## HT812/HT814 Firmware Release Note

## FIRMWARE VERSION 1.0.3.2

HT812 and HT814

## DNS SRV use Registered IP

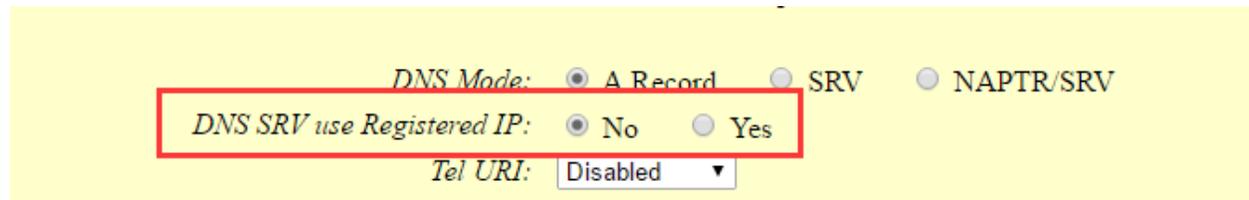
- Added option “DNS SRV use Registered IP” to force DNS SRV to use registered IP instead of use the first SRV.
- Changed default NTP server from us.pool.ntp.org to pool.ntp.org.

If set this option to “Yes”, when registered on second SRV and making an outbound call, it will try the second SRV (registered IP) first. By default, this option is disabled and the DNS SRV will use first SRV instead of the registered IP.

Pvalue	Description	Value range	Default
P28092	DNS SRV use Registered IP. (Profile 1)	0 – No 1 – Yes	0 – No
P28093	DNS SRV use Registered IP. (Profile 2)	0 – No 1 – Yes	0 – No

## PASSWORD CHANGE CONFIRMATION

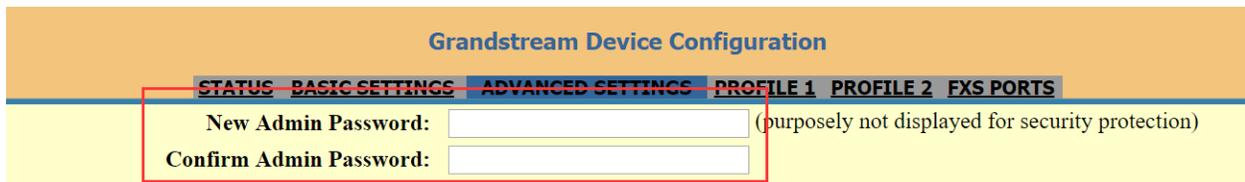
- Added network check mechanism to enable or disable WAN port web access. [WAN PORT WEB ACCESS]
- Added a re-enter box to confirm change user and admin password on web GUI to avoid typo or mistakes. [PASSWORD CHANGE CONFIRMATION]

Allow user to re-enter the password to confirm the password is input correctly.
